**RE: Application by Tarpon Towers II, LLC ("Tarpon") and Bell Atlantic Mobile System LLC d/b/a Verizon Wireless ("Verizon Wireless") for the approvals necessary to construct and operate a 235' wireless telecommunications tower (with 4' lightning rod) and associated improvements on land owned by Calcam Associates, Inc., located off Pine Tree Street (S.B.L. #35-1-27.1) in the Town of Thompson, Sullivan County, New York (Verizon Wireless' "Louise Marie" site)**

Thereafter, we received Technical Review Comments dated February 12, 2020 from Richard D. McGoey, the Town's Engineer (the "Engineer Comments"), as well as comments from Helen Budrock, AICP of Delaware Engineering, D.P.C. dated February 19, 2020 (the "Delaware Comments"). This letter (including Exhibits SS-UU) is submitted in response to the Engineer Comments and is intended to supplement the Application (and Exhibits A-RR previously submitted therewith). The Engineer Comments and Delaware Comments are each noted below in bold italicized type, with Verizon Wireless' responses in regular type.

SHEET NUMBER  
C-1A

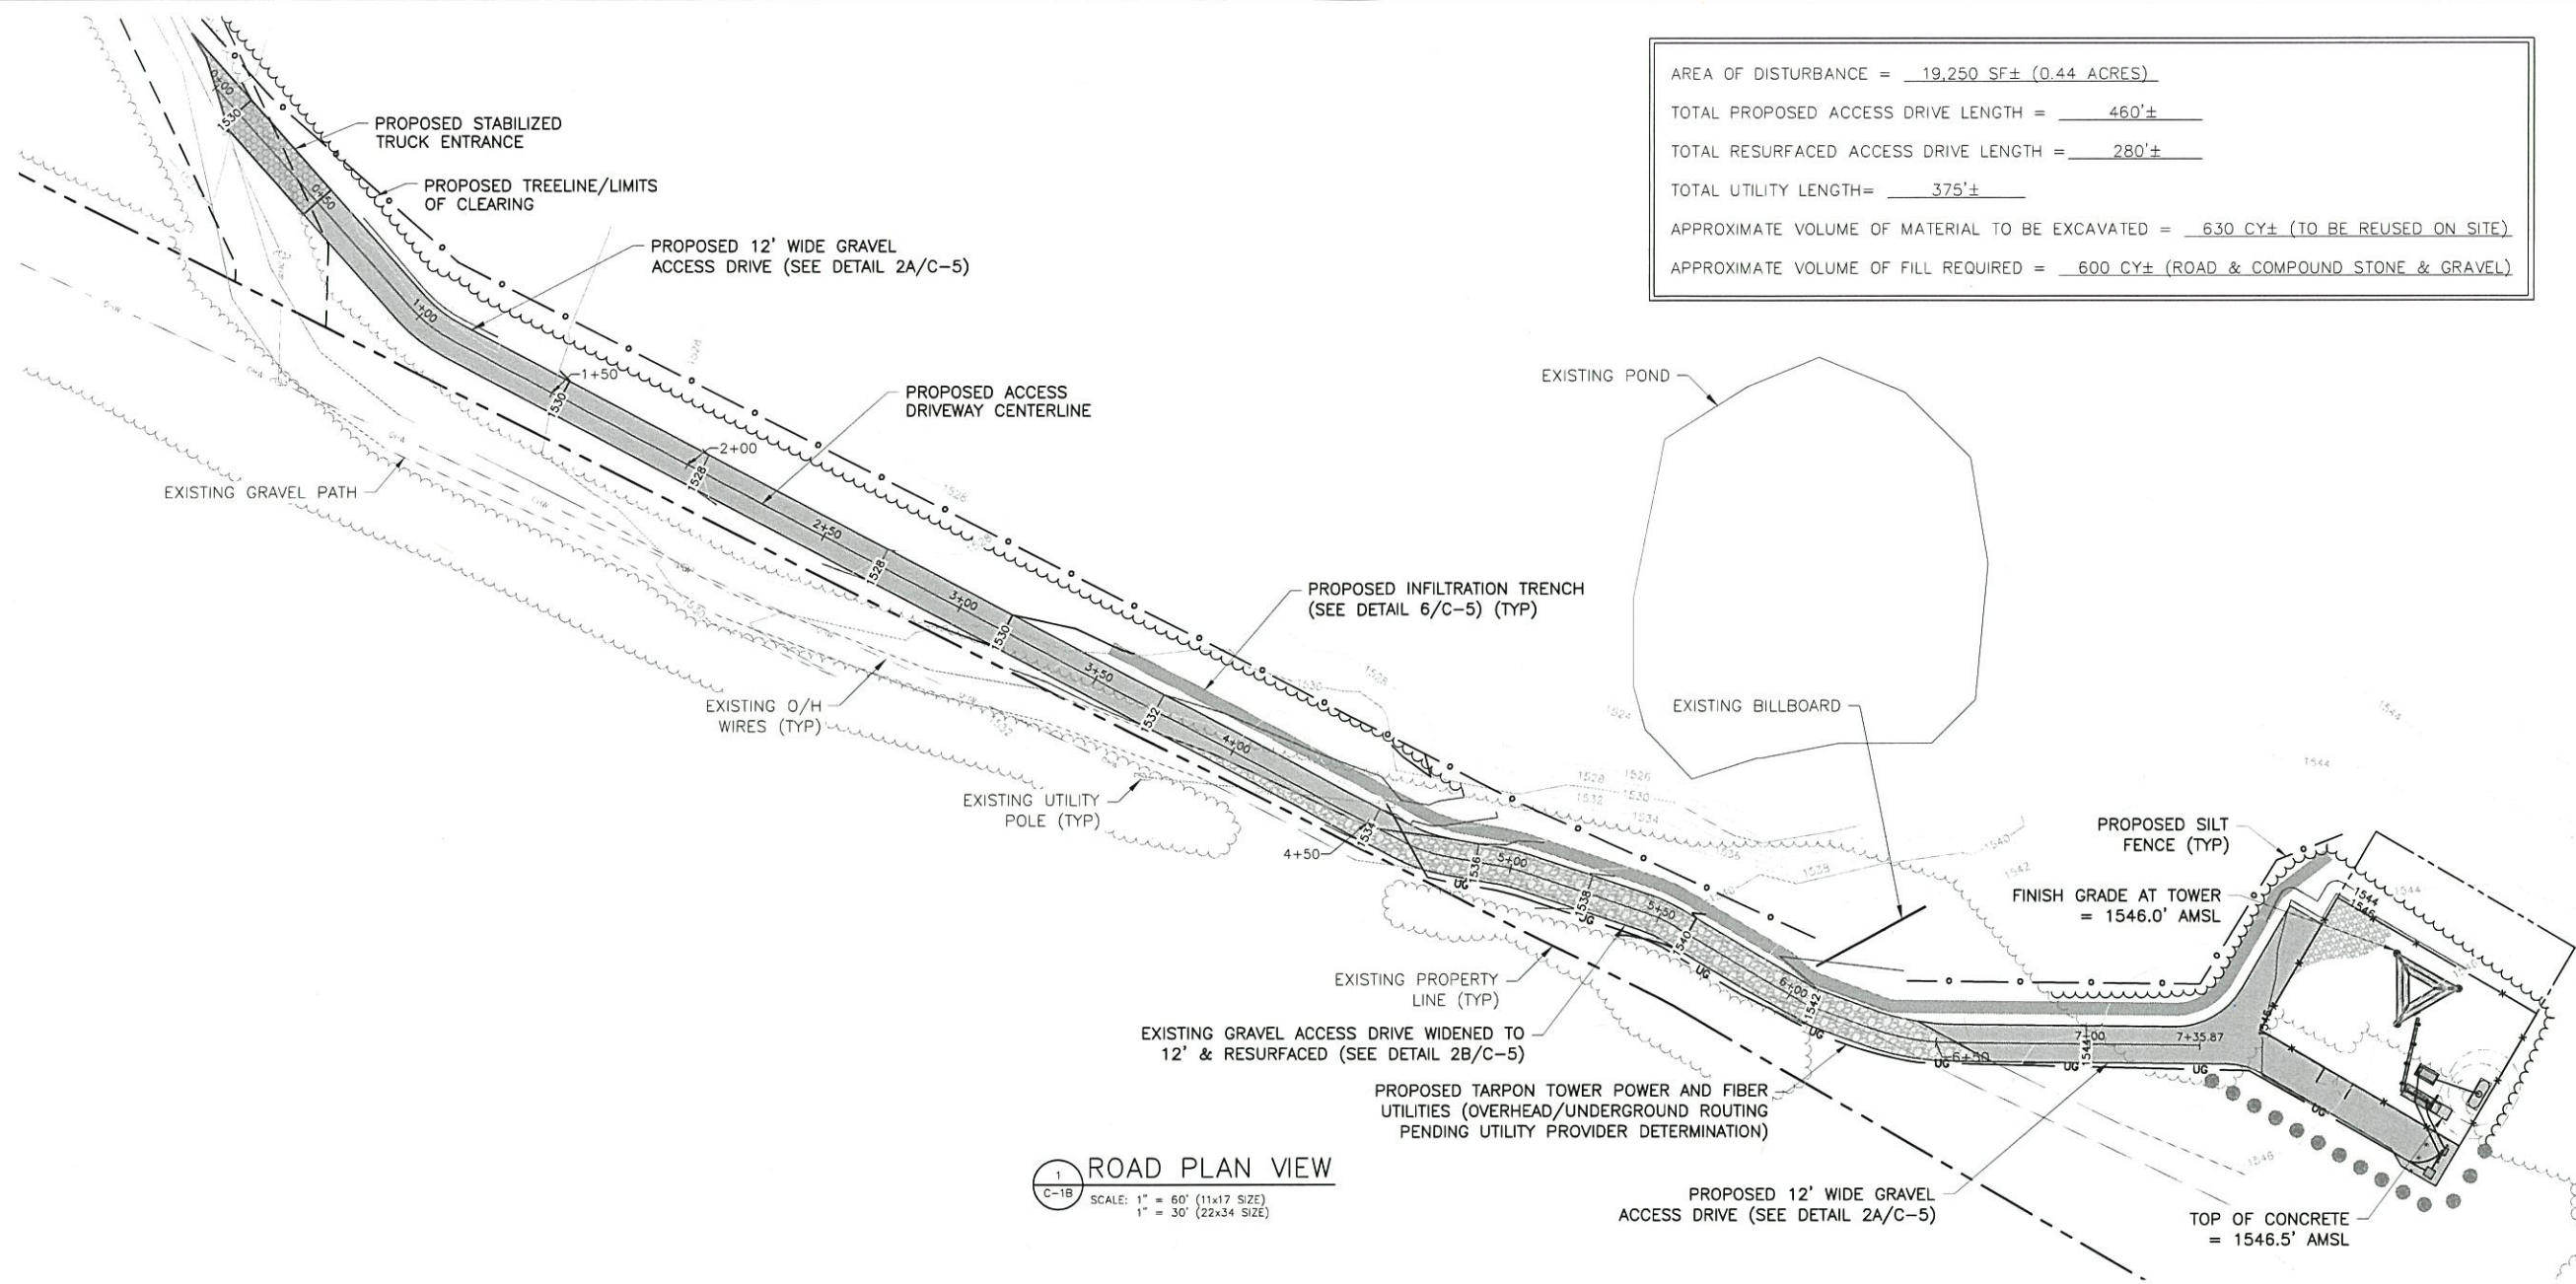
8. *The site plan sheets C-1B shows that only a portion of the access road will be developed to 12 feet wide with a gravel surface. Other portions of the access drive, in our opinion, will also require a stable surface treatment based on our field observation of soft wet conditions along other sections of the access drive. The proposed construction of underground utilities along the access drive will also further deteriorate the existing road conditions and therefore will require stabilization and roadway surface treatments.*

Response: See Sheets C-1A and C-1B of the Revised Plans. Additional improvement of the access drive has been proposed. Note that a continuous gravel drive now extends from Pine Street to the tower compound.

1 ELEVATION  
C-3  
SCALE: 1" = 40' (11x17 SIZE)  
1" = 20' (22x34 SIZE)

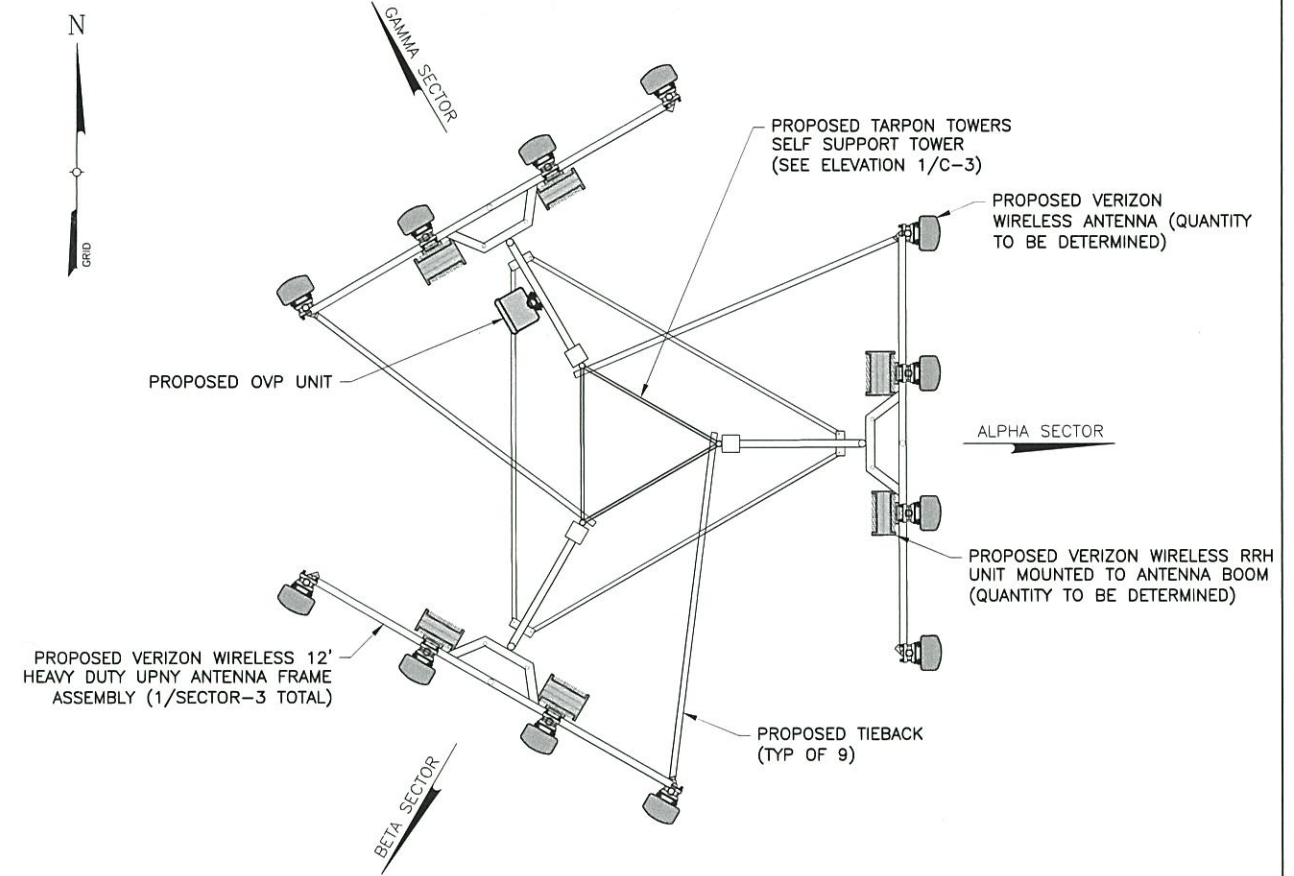
3. *Pursuant to § 250-68 new telecommunications towers must be designed to accommodate future demand for reception and transmitting facilities. The applicant should amend sheet C-3 (Elevation and Orientation Plan) to describe the opportunities/capacity for co-location on this tower and show the potential location(s) for future antennas and related equipment.*

Response: See Exhibit SS and Sheets C-2 and C-3 of the Revised Plans. Future co-location is accommodated in the design of both the compound and tower.

SHEET NUMBER  
L-1

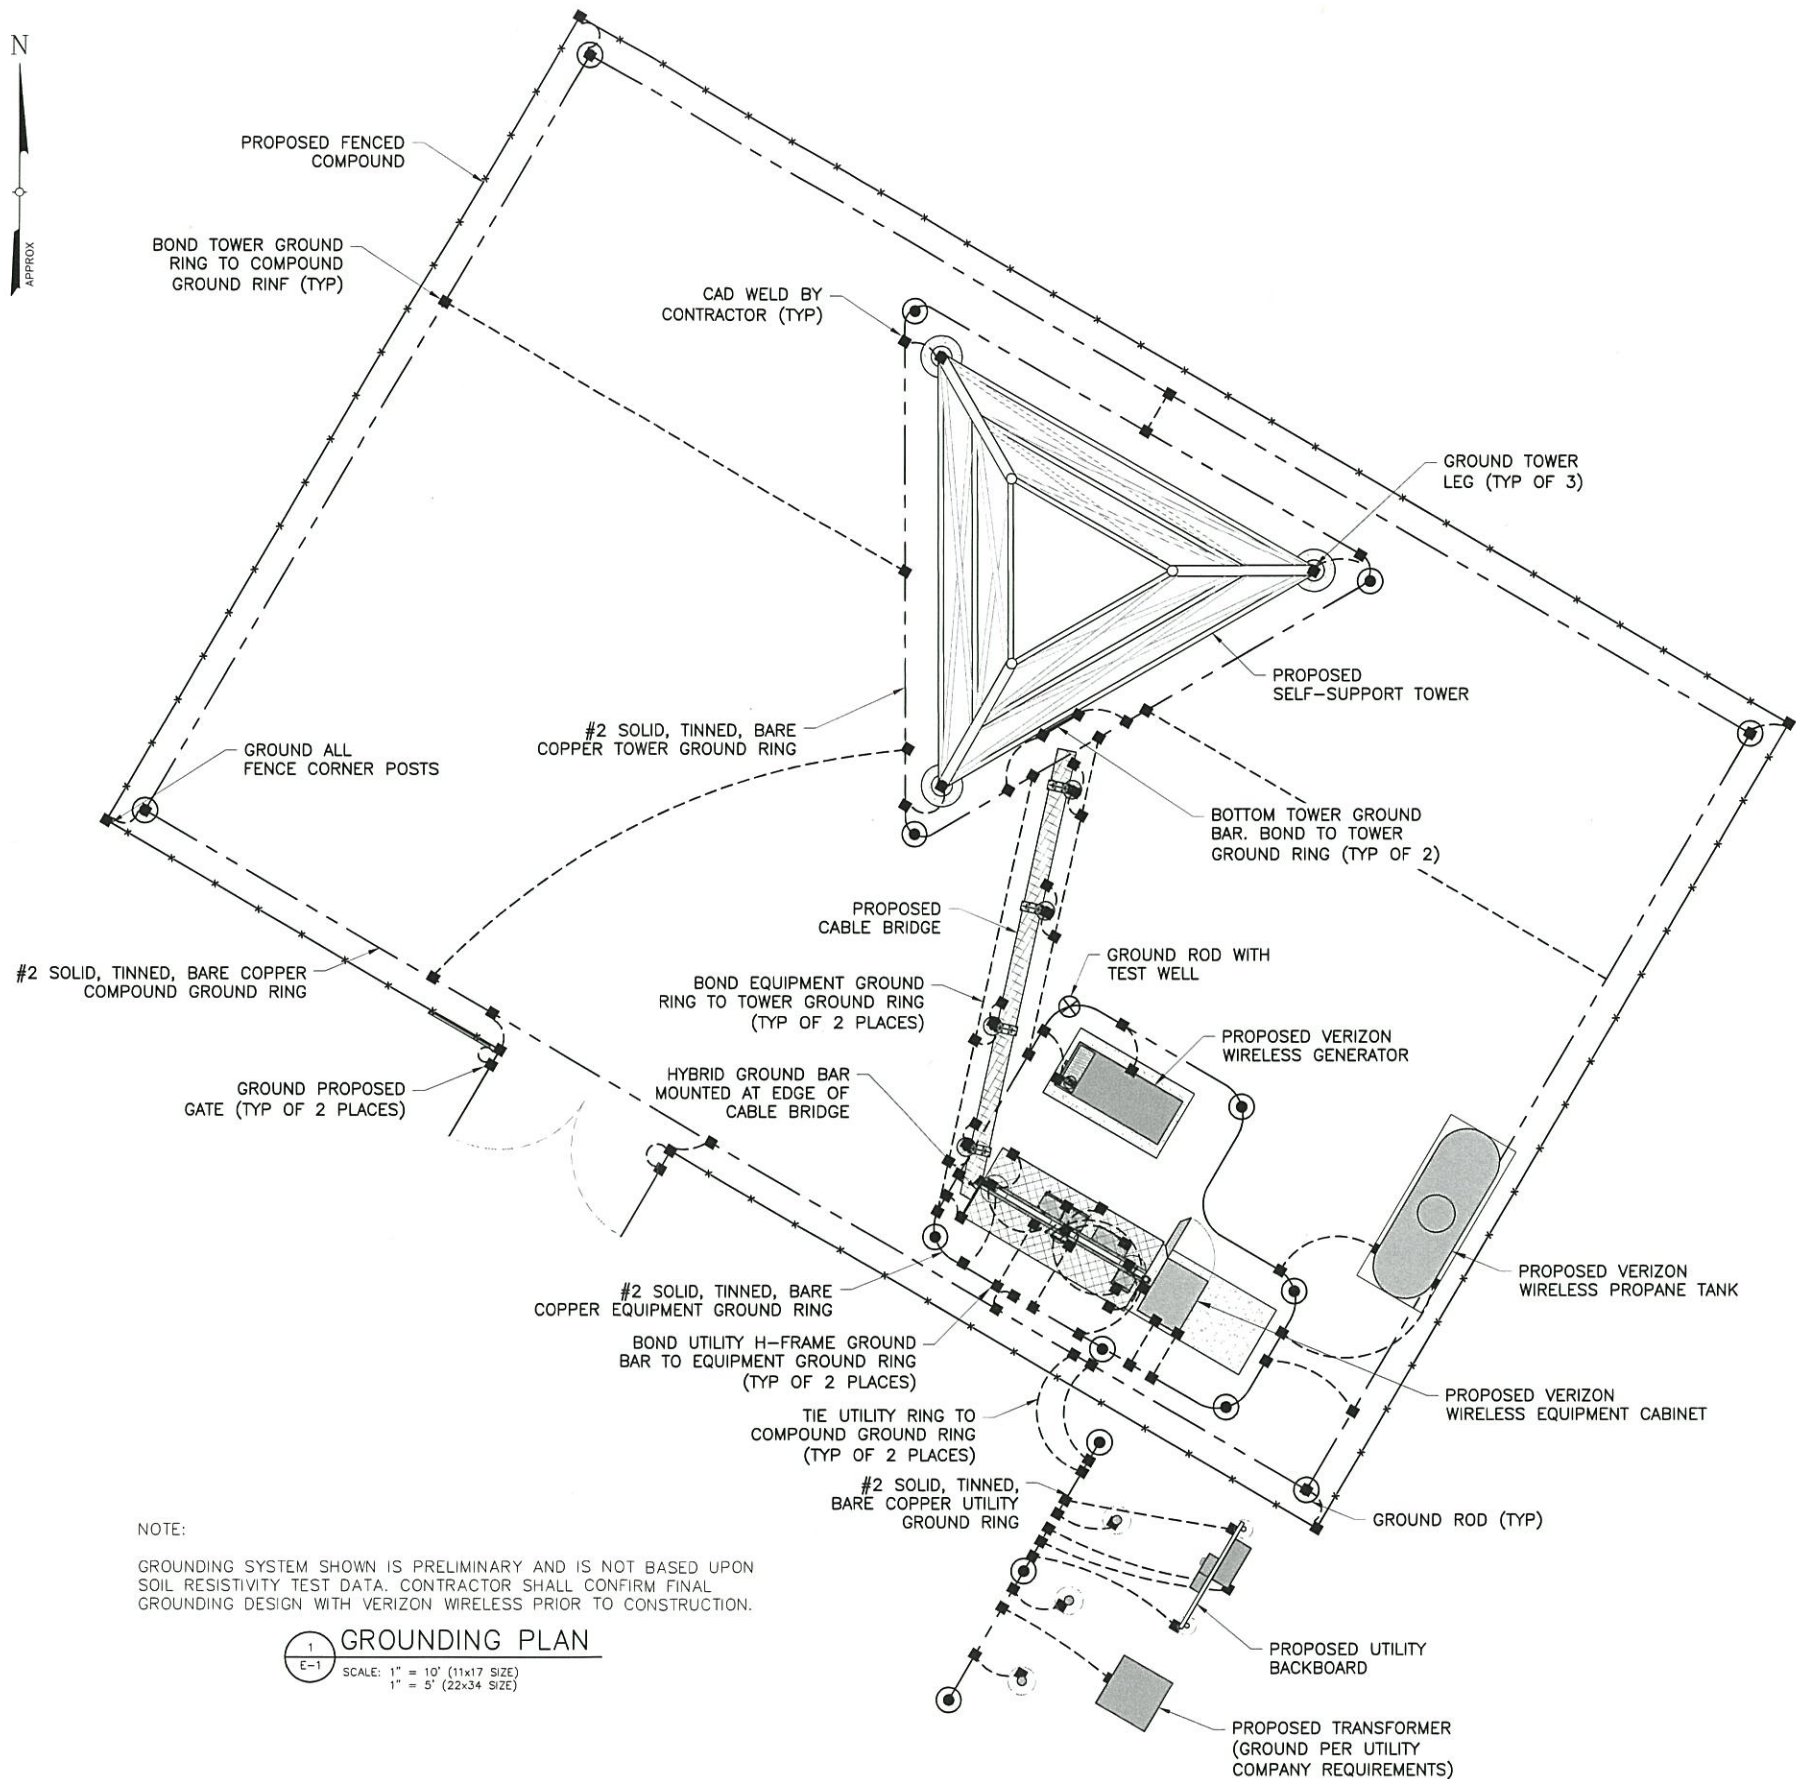
6. *Since the site abuts NYS Route 17 – a highly visible and heavily-trafficked roadway – we recommend that the applicant submit a landscaping plan providing details on proposed screening of the fence enclosure at the tower base pursuant to § 250-74.*

Response: See Sheets C-2 and L-1 of the Revised Plans.
